Geosci. Model Dev. Discuss., author comment AC2
<https://doi.org/10.5194/gmd-2021-53-AC2>, 2021
© Author(s) 2021. This work is distributed under
the Creative Commons Attribution 4.0 License.

Reply on RC2

Author comment on "HydroPy (v1.0): a new global hydrology model written in Python" by
Tobias Stacke and Stefan Hagemann, Geosci. Model Dev. Discuss.,
<https://doi.org/10.5194/gmd-2021-53-AC2>, 2021

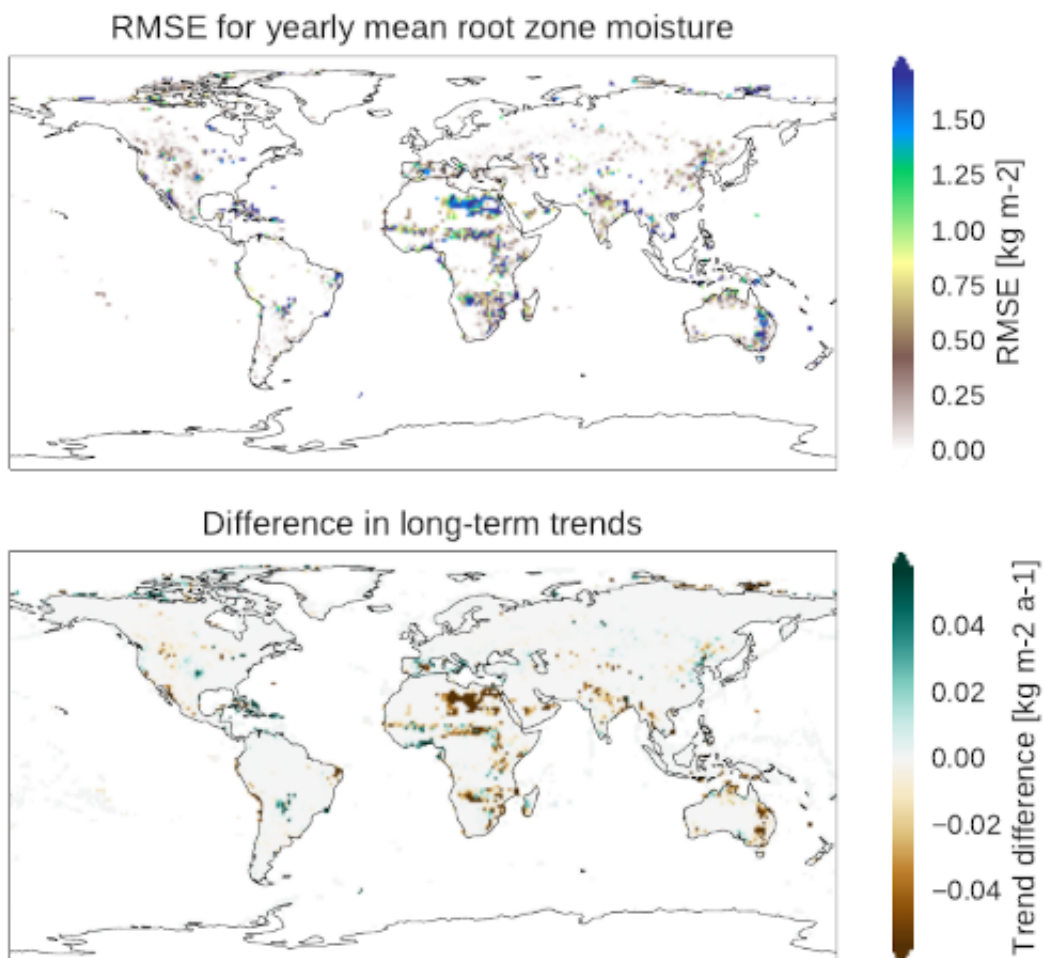
Lines 286-287: "The simulation ... until 2014". If I understand correctly, you are trying to bring your model to an equilibrium using conditions in a single year (1979). Wouldn't it be

better to use a range of years or at least a climatology?

Yes, our intention is to provide the model with a storage state where changes are dominated by climate input and not by any residual trends. There are several (small) advantages and disadvantages to the methods: using a climatology might reduce the day to day variability and thus limit the model's exposure to any daily extremes. Picking just one year (as we did) could lead to a bias in storage state in case the particular year happens to be an extreme year in a given region but allows for a very clean setup with a constant storage target, which the model approaches. Using a time series for spinup generates the exact opposite, e.g. extreme years and therefore an anomalous storage state are less likely. However, the target state is less well defined due to inter-annual variability. We decided to use the approach with the best defined target state because it allows for a more straight forward evaluation of the spinup behavior. Anyway, we claim that our model is not very sensitive to either method as long as the number of spin-up years and the general climate are similar. In order to test this hypothesis, we performed another spin-up simulation using a time series from 1930 until 1979 (instead of a single year) as well as another production simulation from 1979 until 2014 based on this spinup. We then compared our original simulation and the new simulation (Fig 1). This comparison demonstrates that indeed both methods cause differences in the production simulation. However, these differences are very low resulting in an RMSE which rarely exceeds 5 kg m⁻². Furthermore, the long term trends found in both simulations are very similar with only a small numbers of grid cells that show different trends due to the different spinup methods. From this, we conclude that the choice of spinup method has only a minor effect on our results.

Figure 2: Spatial distribution of yearly trends during the last 10 cycles of the spinup simulation.

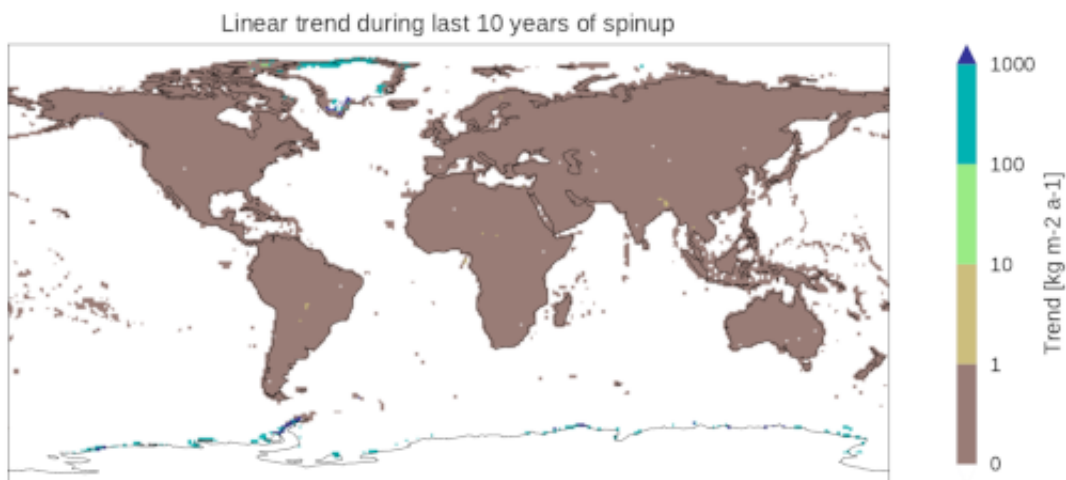
Lines 306-320: I very much doubt that checking for the pixel with the largest absolute residual trend is sufficient proof that the model is in equilibrium. In many regions, the absolute storage trends are small because the involved water flows (precipitation, runoff, recharge, discharge) are small. Thus, storages (and fluxes) will take much longer to reach equilibrium in regions where initial storage trends are small (a fairly large part of the world, according to the map in Figure 3). This is of minor concern when considering globally aggregated fluxes, which are dominated by regions with large fluxes. But I suspect that many of the other results presented in the remainder of the paper are affected by storages not being in equilibrium at the beginning of the simulation phase. I strongly suggest using a different indicator for quantifying the proximity to equilibrium and adjusting the spin-up protocol accordingly.

We used this method exactly for the reason you mentioned: any residual trend is most likely only found in regions where the annual water turnover is much smaller than the storage capacity. However, we think such regions are very few and do not interfere with any of our analysis, either on global nor on catchment scale. To some part this is already demonstrated in Fig 1 (right panel) which shows the similarity of simulated long-term trends in spite of using different spin-up methods. Additionally, you can see in Fig. 2 the trends in total water storage for the last 10 years of spinup up simulation. Apart from the already discussed grid cells in glaciated regions, there are very few grid cells which show any residual trend (still being rather low with $< 5 \text{ kg m}^{-2} \text{ a}^{-1}$), but these are located in rather wet regions like the Ganges Delta and the Pantanal wetlands. Based on this analysis, we are confident that none of our results are significantly affected by spinup. We will extent Fig 3 of our manuscript to include this plot as well.
